Addenda #1 to

PROJECT NO. ENG2003722634

Brown County State Park

Repair of Historic Stone Walls

GENERAL PLAN LINE 'A' & MAINTENANCE OF TRAFFIC

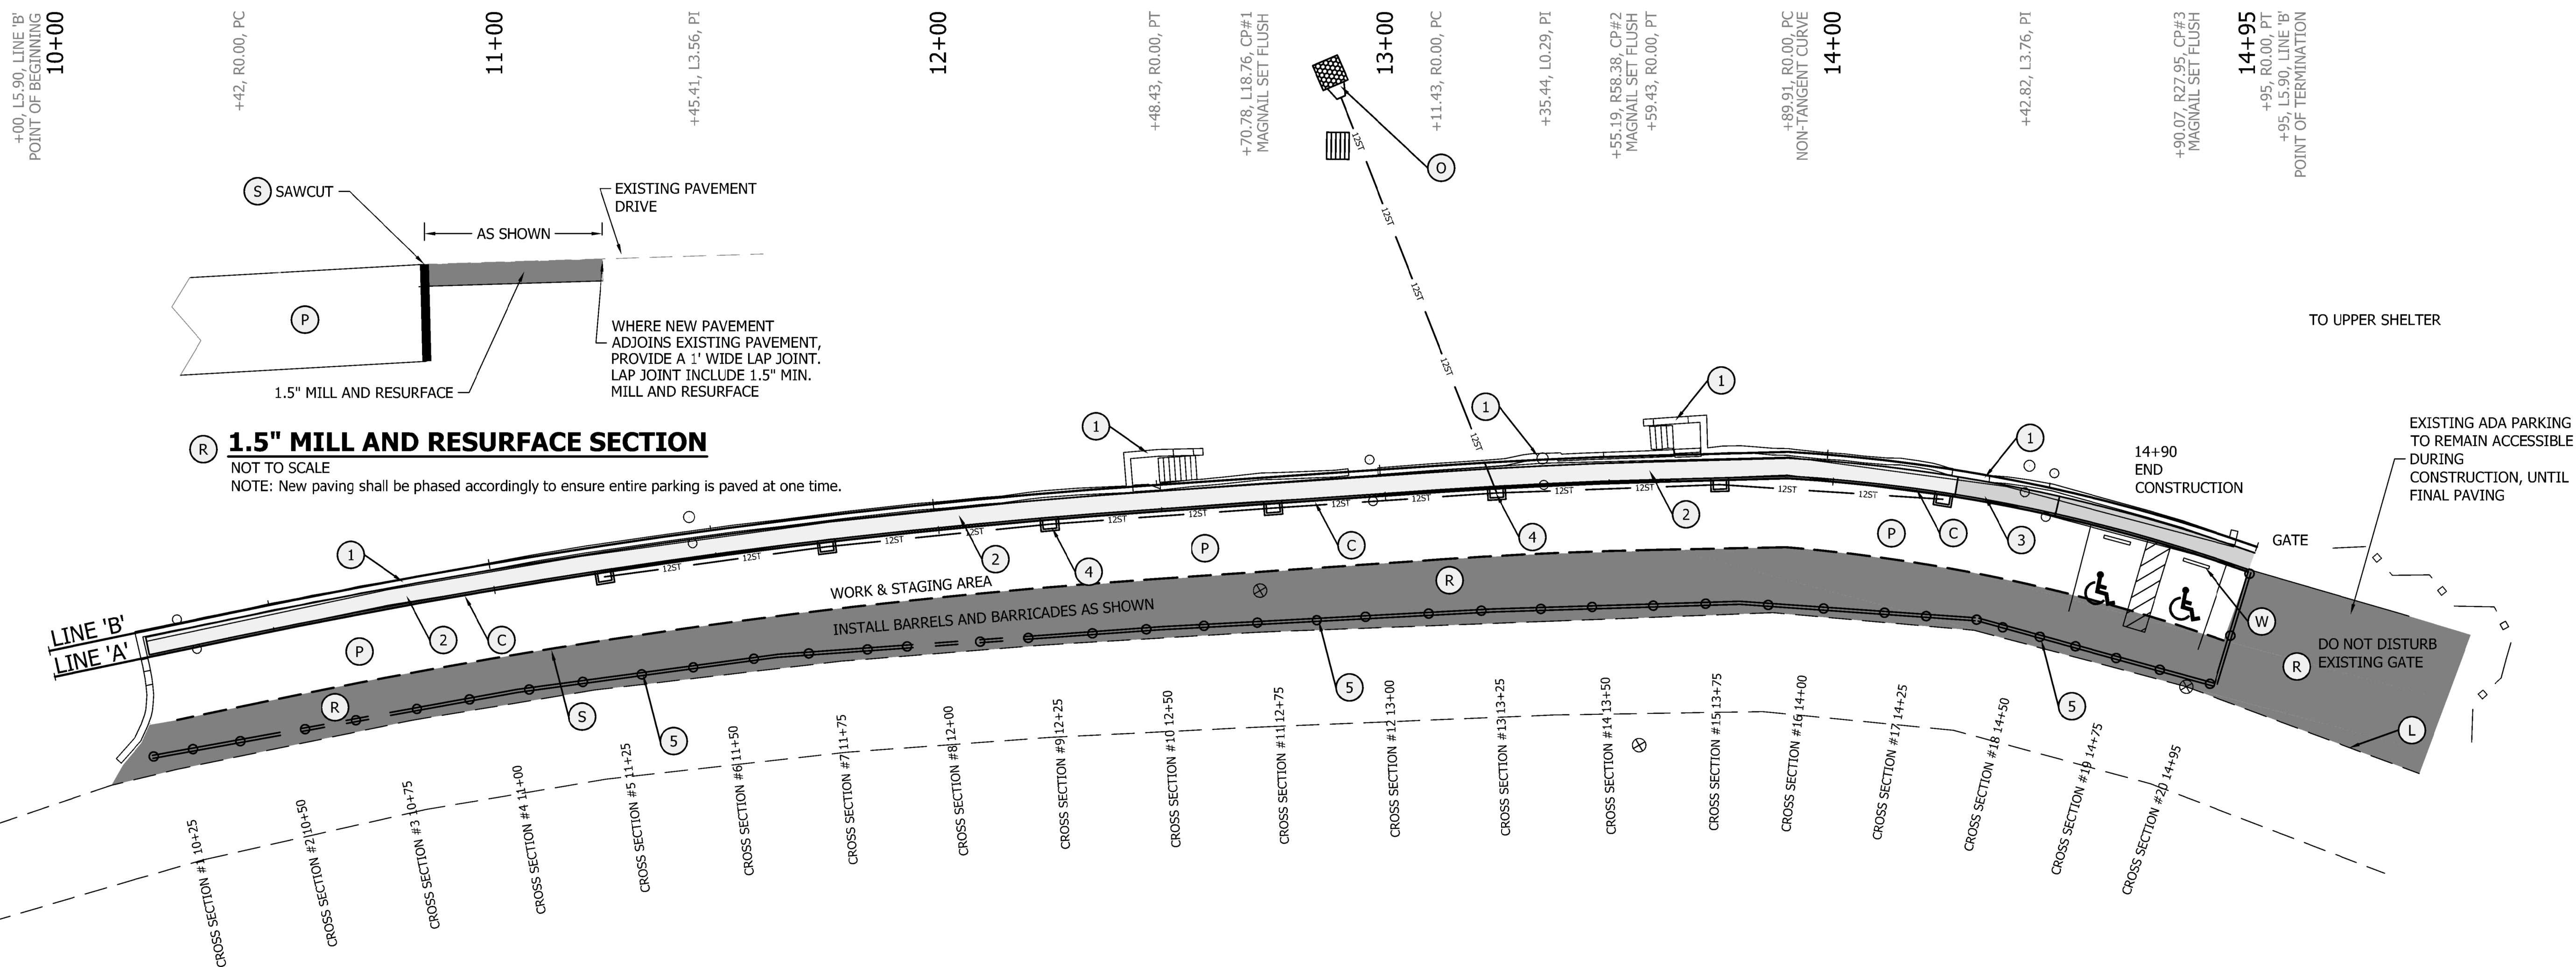
Drawing Sheet 3

Amended as attached Sheet 3 is revised to provide further clarification to the areas of excavation and include resurfacing

- Proposed HMA shall include limits as shown on plans (Paving of existing ADA parking area to be added to proposed HMA area per addendum with revised sheet)

1.5" MILL AND RESURFACE SECTION
 NOT TO SCALE
 NOTE: New paving shall be phased accordingly to ensure entire parking is paved at one time.
